Anglia Square, Norwich Transport Assessment Addendum

Transport Assessment Addendum

Anglia Square, Norwich

Iceni Projects Limited on behalf of Weston Homes Plc

Figure 2.3 – Relocated Edward Street Crossing

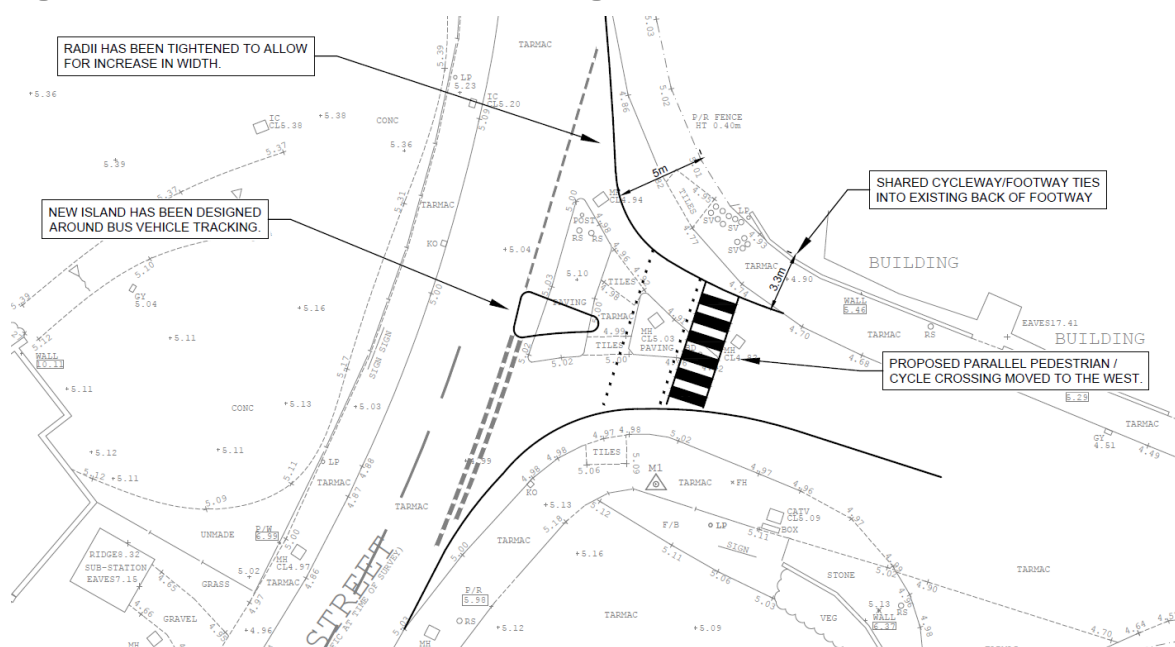
- 2.15 Firstly, on Edward Street (along the main northern site frontage) it has been agreed that crossings are only required at either end of the road i.e. at the junction with Magdalen Street (existing signalised crossing) and at the junction with New Botolph Street (existing crossing which is being upgraded by the proposals). It was advised that the crossing adjacent to Beckham Place was not required and has therefore been removed.

2.16 For the Edward Street / New Botolph Street junction crossing, it was agreed between all parties that this should be shifted in a western direction compared to what was previously proposed, albeit it has still been distanced from the junction to allow a car to sit whilst waiting to either exit the junction or head east on Edward Street without blocking the crossing. The updated design / location of this crossing is shown in **Figure 2.3** and in detailed at **Appendix A5**.

Figure 2.4 – Proposed New Botolph Street Crossing

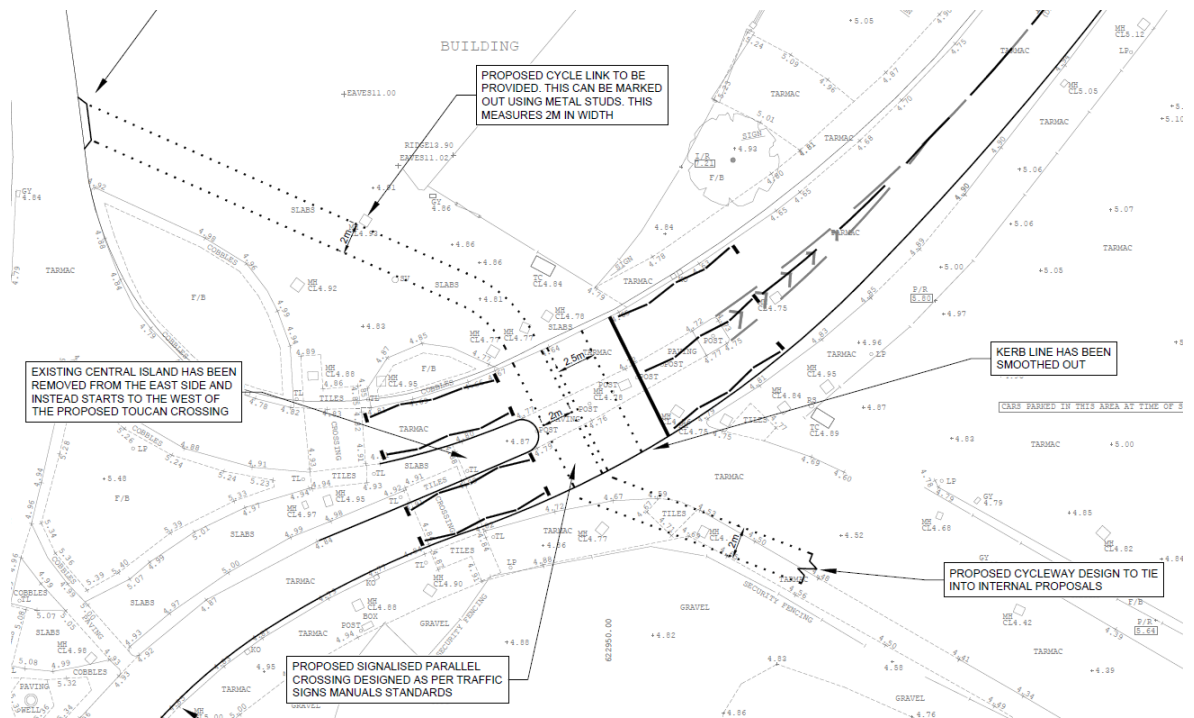
<p>As mentioned in point 5, the current signalised crossing arrangement at junction New Botolph Street/St Augustines should be retained and not changed to a zebra crossing as proposed.</p>	<p>As per the above.</p>
<p>The dimensions for the visibility splay for block E will need to be 2.4m x 43m to increase visibility around the bend and kept free from planted trees and any other landscaping.</p>	<p>Noted and this has been provided – full details in Paragraph 2.11.</p>

2.19 Notwithstanding, an improved crossing facility has instead been proposed, and agreed in principle, on New Botolph Street (just north of Pitt Street). There is currently a signalised crossing broadly in this location, however, it is staggered with a refuge island breaking up the crossing. At the request of NCC / NCoC, what is now proposed is a straight parallel crossing for pedestrians and cyclists with no breaks which will provide a more convenient crossing on what is considered to be an important desire line from the Site to St Augustine’s Street. As well as the crossing, it is also proposed to mark out a cycle track across the footway to the west of the crossing, which will follow the desire line across to St Augustine’s Church.

- 2.20 Given the proposed crossing will be undertaken in a single phase there is no need to retain the current central island, so this has been removed / relocated to start to the west of the proposed crossing. The design for this crossing is shown in **Figure 2.4** and provided at **Appendix A6**.

Figure 2.5 – Proposed Magdalen Street Bus Stops / Crossing

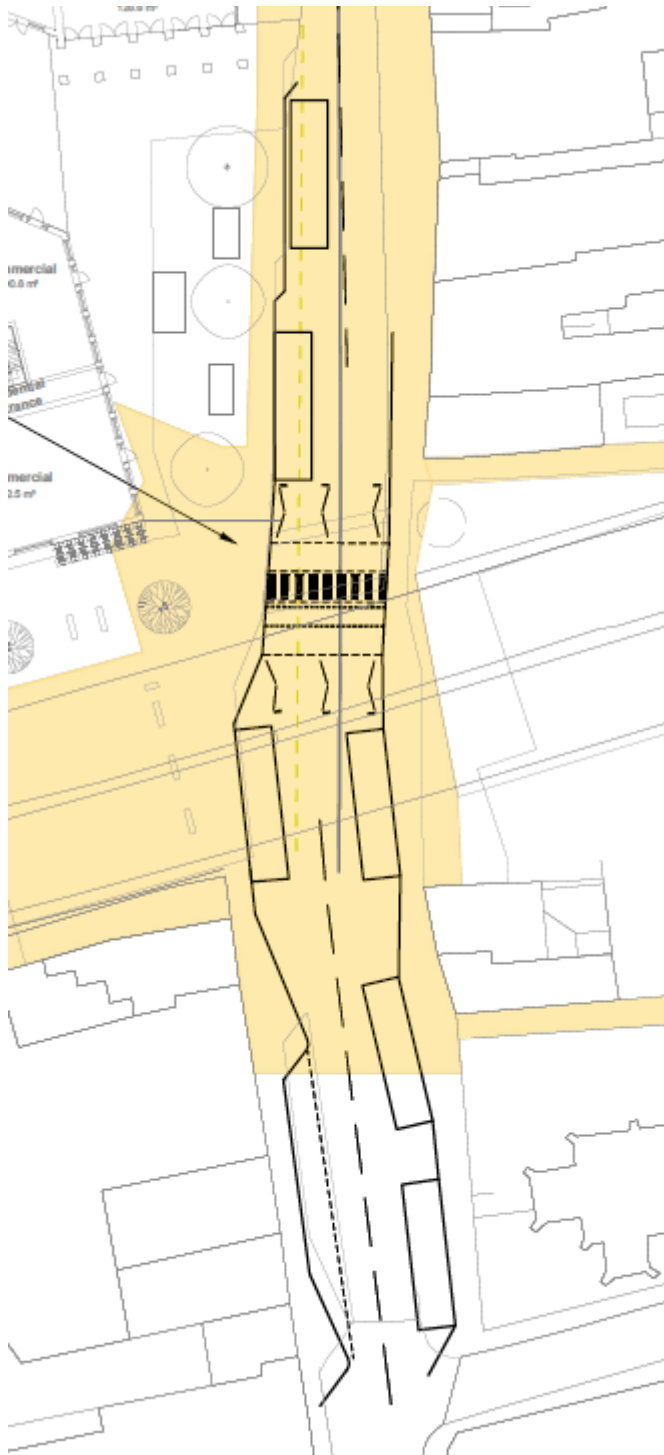
- 2.23 On Magdalen Street, the submitted application made reference to a forthcoming 'Mobility Hub' in this location, however, this would be subject to a separate planning application. However, the NCoC comments highlighted some of these works as being necessary from the outset, and this has been agreed in principle with the Applicant. As such, the detailed design of the bus stop provision and revised kerbs lines, as well as a pedestrian / cycle crossing facility will be resolved via the S106 Legal Agreement.

- 2.24 The crossing previously proposed as part of the Mobility Hub work has been amended so that it crosses the carriageway perpendicular rather than diagonally, at the advice of the NCoC road safety team.
- 2.25 The proposed crossing location and bus stops can be seen on the overall highways plan at **Appendix A4**, but a screenshot is also provided in **Figure 2.5** for reference.

DRAWN BY: AP	CHECKED BY: RJ	APPROVED BY: CB
SCALE @ A1: 1 : 1,000		DATE: 17.12.2021
PROJECT NO: 21-T123	DRAWING NO: 14 (SHEET 1 OF 5)	REV: D

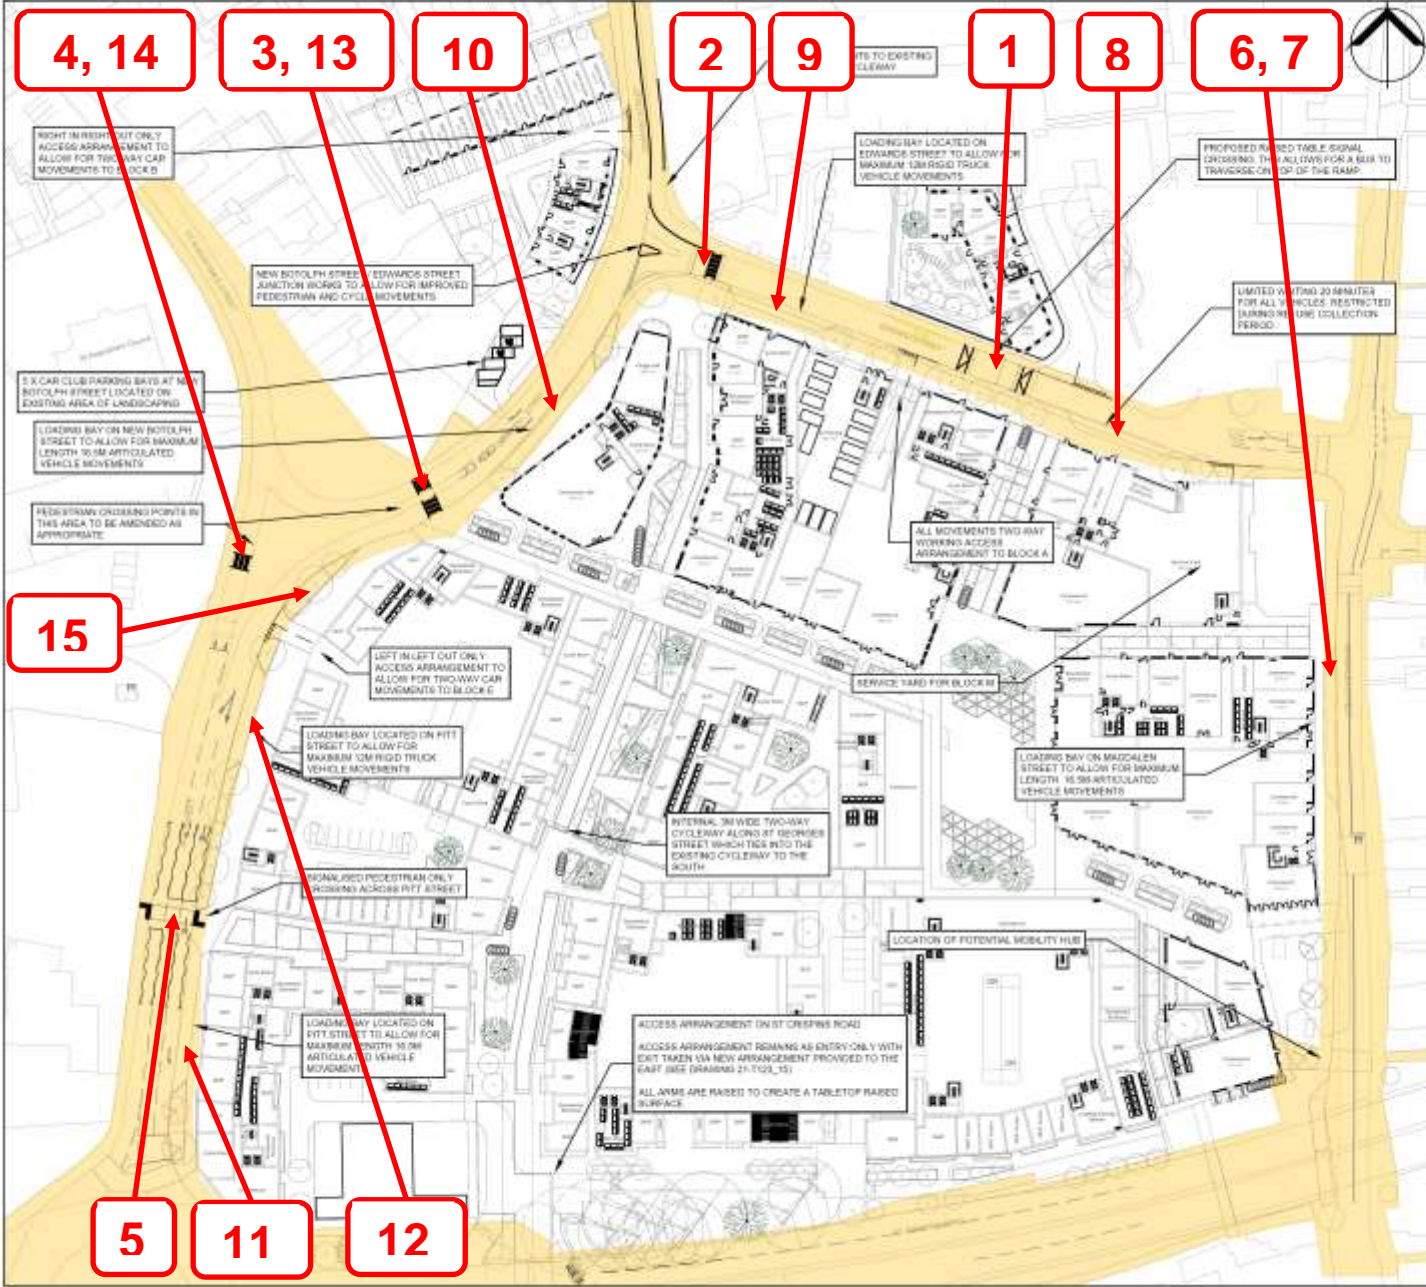
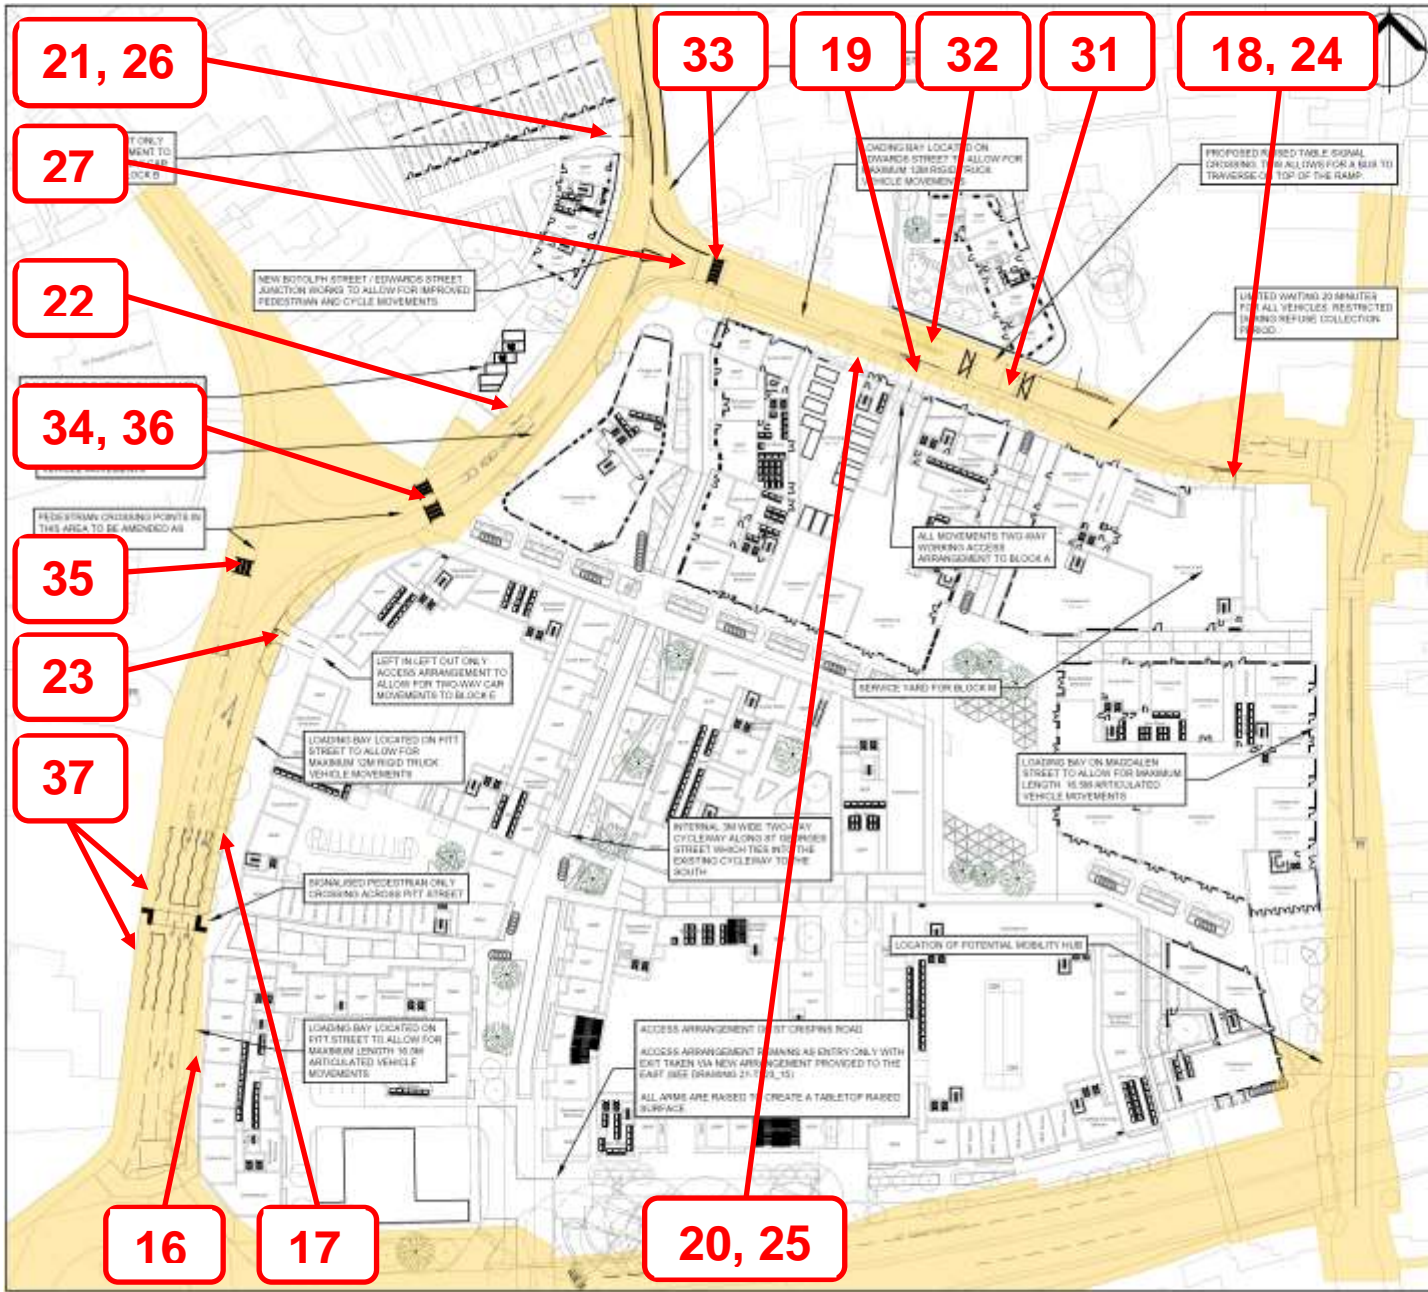
Locations: 1, 2, 3, 4 and 5 - Edward Street, New Botolph Street and Pitt Street, crossing facilities. (Drawing no. 21-T123-14(Sheet 1 of 5) Rev D).

The scheme drawing indicates the provision of signal controlled, parallel and zebra crossing facilities within Edward Street, New Botolph Street and Pitt Street.

Location: 6 - Magdalen Street, loading bay. (Drawing no. 21-T123-14(Sheet 1 of 5) Rev D).

As a result, restricted forward visibility could lead to a potential increased risk of nose to tail shunt type collisions occurring between a leading vehicle braking heavily upon a change in the signals and any following vehicular traffic on approach to the stop line, whereby vehicle occupants could sustain personal injury.

It is recommended that the forward visibility to the nearside primary traffic signal head should be accurately measured and the scheme drawing updated accordingly. When occupied, should the inset loading bay impact upon the forward visibility at this location, it is further recommended that the inset loading bay should either be truncated southwards or relocated / removed, in order to mitigate the above described potential collision scenario.

Locations: 13 and 14 - New Botolph Street and Pitt Street, existing signal controlled crossing facilities. (Drawing no. 21-T123-14(Sheet 1 of 5) Rev D).

The scheme drawing indicates that the existing signal controlled crossing facilities are to be removed and replaced with zebra crossing facilities on New Botolph Street and Pitt Street.

Location: 15 - New Botolph Street / Pitt Street, proposed trees (Drawing nos. 21-T123-14(Sheet 1 of 5)).

The scheme drawing indicates trees are proposed to be planted on the bend of New Botolph Street / Pitt Street at the location indicated.

Locations: **34** and **35** - New Botolph Street and Pitt Street, zebra crossings. (Drawing no. 21-T123-14(Sheet 1 of 5) Rev D)

The scheme drawing indicates that the existing signal controlled crossing facilities are to be removed and replaced with zebra crossing facilities on New Botolph Street and Pitt Street.

It is recommended that raised tables should be incorporated into the proposed zebra crossing facilities, in order to provide consistency and speed control in this area.

Location: **36** - New Botolph Street, zebra crossing. (Drawing no. 21-T123-14(Sheet 1 of 5) Rev D)

The scheme drawing indicates the existing staggered signal controlled crossing facility on New Botolph Street is to be removed and replaced with a zebra crossing facility further east from its current location.

The scheme drawing also indicates that the zebra crossing is to be split by the existing narrow traffic separation island on New Botolph Street.

Location: 37 – Pitt Street, existing vehicular crossovers (Drawing no. 21-T123-14(Sheet 1 of 5) Rev D).

The scheme drawing indicates a signal controlled pedestrian crossing facility is proposed on Pitt Street.

In order to provide the dropped kerb facility for the tactile paving surface of the signal controlled crossing facility, the two existing vehicle crossovers leading to the parking bays either side of the building may need to be realigned in order to accommodate the stop line and tactile paving.

It is recommended that the existing vehicular crossovers should be indicated on the scheme drawing in relation to the proposed signal controlled pedestrian crossing facility.

Additionally, it is recommended that the existing dropped kerb layout leading to the designated parking bays should be modified to incorporate the dropped kerb facility and controls for the proposed signal controlled pedestrian crossing facility, in order to mitigate the above described potential collision scenario.

RSA problem	RSA recommendation	Design organisation response	Overseeing Organisation response	Agreed RSA action
2.2.1) Edward Street, New Botolph Street and Pitt Street, crossing facilities. Reducing the potential risk of skidding and enhancing braking capacity on the approaches to the proposed crossing facilities located on Edward Street, New Botolph Street and Pitt Street, in order to minimise potential vehicular and pedestrian/pedal cyclist collisions occurring, as well as vehicular collisions occurring, whereby pedestrians, pedal cyclists and vehicle occupants could sustain personal injury.	<p>It is recommended that a high skid resistant surface course material (formerly referred to at the wearing course), should be provided on the approaches to the proposed signal controlled, parallel and zebra crossing facilities.</p> <p>It is suggested that as a minimum, the length of the high skid resistant surface course (formerly referred to at the wearing course), should be based on vehicular approach speeds and recognised stopping distances in the Highway Code.</p>	<p>Noted – correct surface treatment, in accordance with standards, to be provided on approach to all proposed crossings.</p> <p>Details to be provided at Stage 2.</p>

RSA problem	RSA recommendation	Design organisation response	Overseeing Organisation response	Agreed RSA action
2.2.2) Magdalen Street, loading bay. Restricted forward visibility to the nearside primary traffic signal head could result in a potential increased risk of nose to tail shunt type collisions occurring, whereby vehicle occupants could sustain personal injury.	<p>It is recommended that the forward visibility to the nearside primary traffic signal head should be accurately measured and the scheme drawing updated accordingly. When occupied, should the inset loading bay impact upon the forward visibility at this location, it is further recommended that the inset loading bay should either be truncated southwards</p>	<p>Not accepted. The loading bay has been recessed to allow for this. The road alignment on approach to signals fractionally bends in an eastward direction and the position of the driver would be more towards the middle / centre of the road when looking towards the signal heads.</p>

RSA problem	RSA recommendation	Design organisation response	Overseeing Organisation response	Agreed RSA action
<p>2.2.4) New Botolph Street and Pitt Street – existing signal controlled crossing facilities. Lack of signage for motorists with regard to direction of travel and banned turns could result in a potential increased risk of vehicular collisions occurring within the junction area, whereby vehicle occupants could sustain personal injury.</p>	<p>It is recommended that the signage contained with the existing traffic signal heads should be replicated via a post and plate system on the adjacent footways, in order to mitigate the above described potential collision scenarios.</p>	<p>The proposals for this area have been updated following discussions with Norwich & Norfolk Council officers. The proposals now include a new signalised crossing facility on New Botolph Street. Proposed signal heads will include the required signage. Detail to be provided at Stage 2.</p>

RSA problem	RSA recommendation	Design organisation response	Overseeing Organisation response	Agreed RSA action
<p>2.2.5) New Botolph Street / Pitt Street – proposed trees. Restricted forward visibility on the bend could result in a potential increased risk of nose to tail shunt type collisions occurring, whereby vehicle occupants could sustain personal injury.</p>	<p>It is recommended that the forward visibility at this location should be accurately measured and the scheme drawings updated accordingly. Any vegetation falling within the forward visibility should either be removed or relocated, in order to mitigate the above describe potential collision scenarios.</p>	<p>Not accepted – the trees will fall within the inter-visibility and forward visibility splays and as such the canopy will be over 2m in height and the species chosen will be planted in such a way that the trunks do not make a continuous barrier to visibility. As such, this would be no different from a telegraph pole and lamp column.</p>
